Pool and Spa Facilities Update

Summary of Aqua Design International (ADI) Facility Evaluations

October 2024

East Center

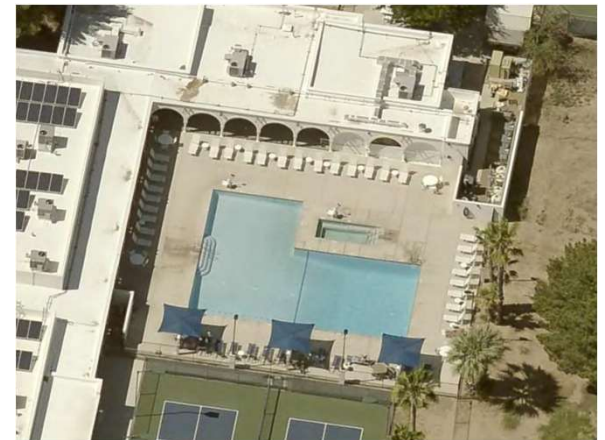
- ☐ Install shade structure to protect value equipment from sun damage

- ☐ Remove minor scale build-up on pools, spa, rails, tiles. Use 3M pad or media blast
- ☐ Service the 5 Pentair ETI heaters on a regular basis. Get Pentair training.
- ☐ Clean pool deck with TSP and pressure washer to remove staining.
- ☐ Ensure pool drains are VGB compliant. Must have labels. Replace every 3 to 5 years.
